KAM VHF OUTPUT  
MODIFICATION  
WARREN VK3XSW  
30.7.2

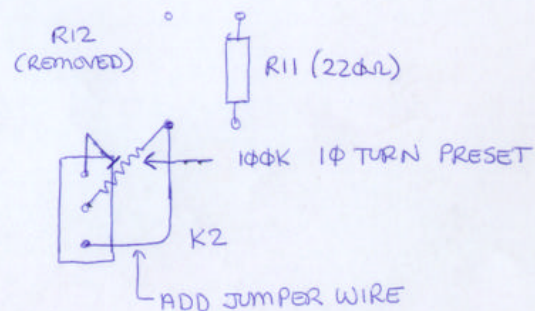
#### MODIFICATION

- REMOVE JUMPER BLOCK  $K2$
- REMOVE RESISTOR  $R_{12}$  ( $1K\Omega$ )
- INSERT  $100K\Omega$  10 TURN PRESET AS SHOWN

\*  $R_{11}$  SETS MINIMUM OUTPUT LEVEL ( $10mV$ )

MIN -  $10mV$

MAX -  $1.2V$

VARIABLE BETWEEN  $10mV$  AND  $1.2V$
